CITY OF PORTLAND BUILDING PERMIT

Job ID: 2011-11-2757-SF

has permission to Build new 26' x 36' 2 1/2 story duplex

RE: C. of O. for # 29-31 True Street,
Sniper Duplex
(Id#2011-11-2757- SF) (CBL 424 A 007001)

DWELLING UNIT SEPERATION
WALL CROSS SECTION
1/2"=1'-0"

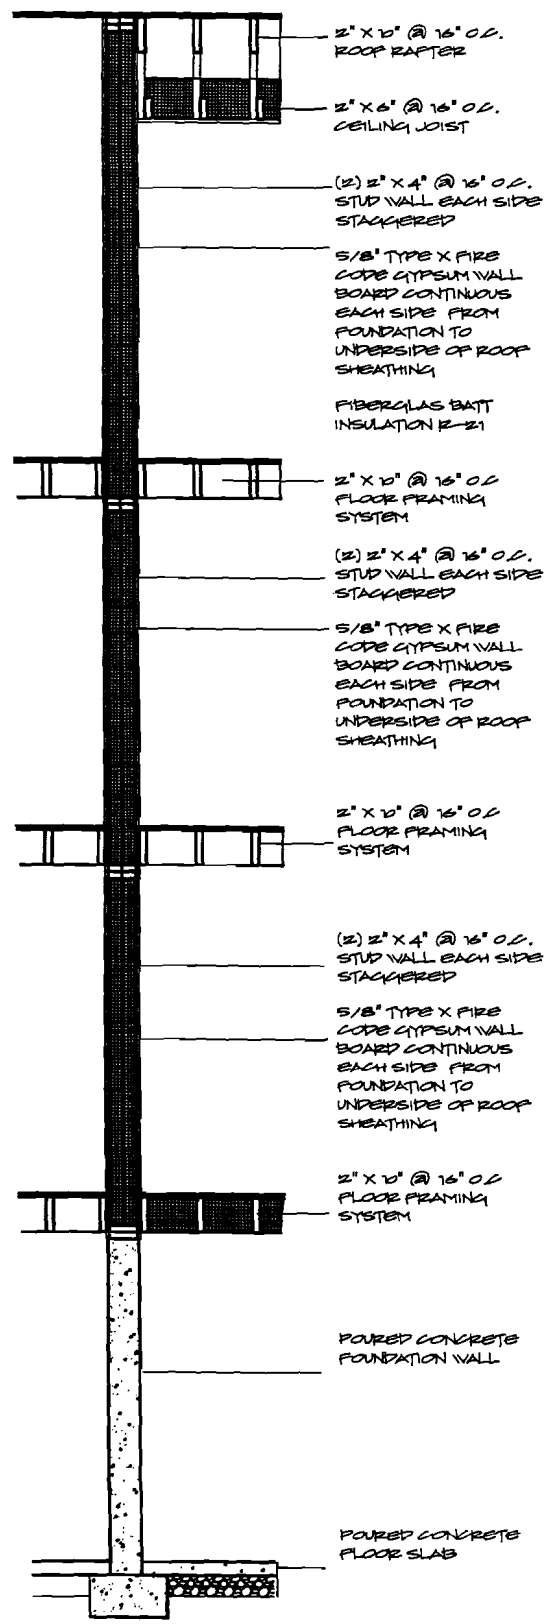
- A Cross Section of the Two Family Dwelling Unit Separation (Section R302.3)
- A Cross Section of the Second Floor Framing/ Girder(s) in Compliance with (Table R502.5(1))
- Basement/ Attic Emergency Escape (Section R310); Indicate change(s) in footprint on revised Plot Plan if a Bulkhead is utilized.
- Basement Stairwell Landing (Winder) in compliance with (Section R311.7.5)
- Building Envelope Energy requirements must comply with MUBEC

Revised 1/9/12 Add Bulkheads

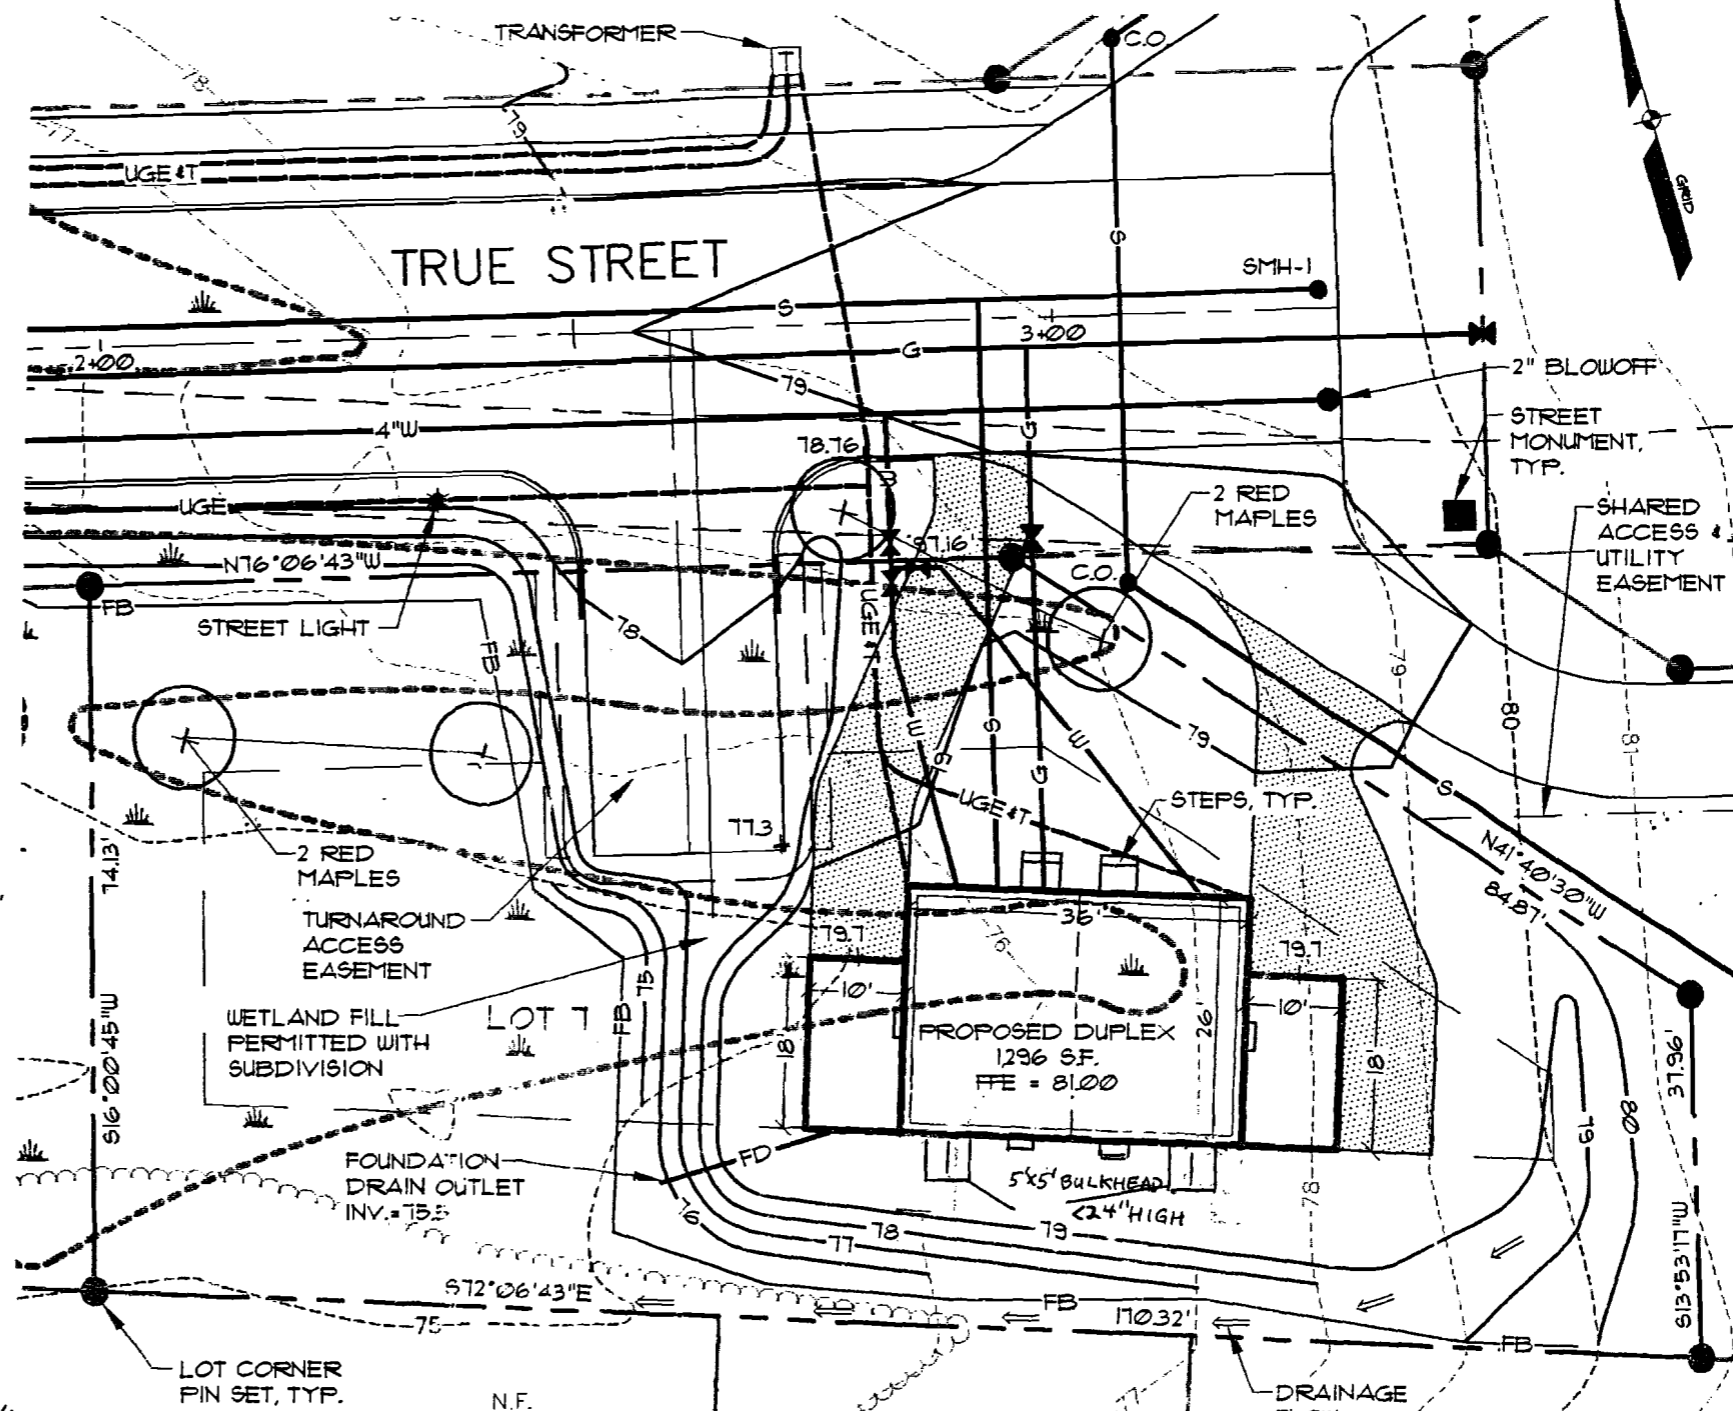
Revised plan 12/13/11
* * * revised plan 11/10/12 - added two bulkheads.

Side Yard - 2 1/2 stories - 14' - ^{33'} ~~29'~~ from front left corner - left side OK * * * two bulkheads each 28.4' - net extends approx 4" - OK section 14-425.
- ~~29'~~ ^{33'} from on right side OK
